Docket Item #6
BZA CASE #2006-0044

Board of Zoning Appeals
October 12, 2006

ADDRESS: 323 NORTH SAINT ASAPH STREET
ZONE: RM, RESIDENTIAL
APPLICANT: CARL GUDENIUS AND LAURIE LOWE

ISSUE: Variance to construct a rear addition reducing the required open space.

Location of addition and required parking in compliance with zoning.

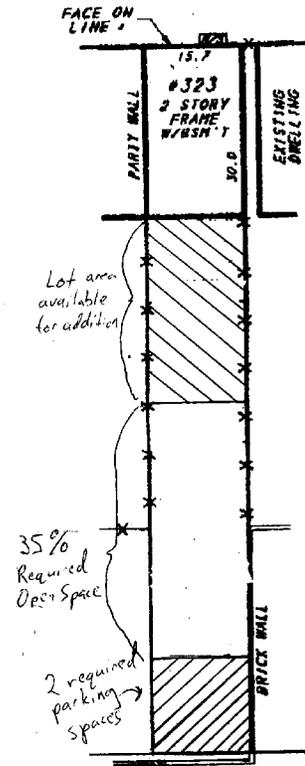
Staff finds that the strict application of the zoning ordinance does not result in a legal hardship for the applicants. At 1,980 square feet, the property is well over the minimum lot size of 1,452 square feet for the RM zone. If built as proposed, the subject property will have 561 square feet of open space. With resizing of the required parking spaces at the rear of the property there would be enough lot area to build a rear addition at least 30 feet deep and still maintain the required 693 square feet of open space as well as the two required parking spaces.

Based upon the above findings, staff **recommends denial** of the variance.
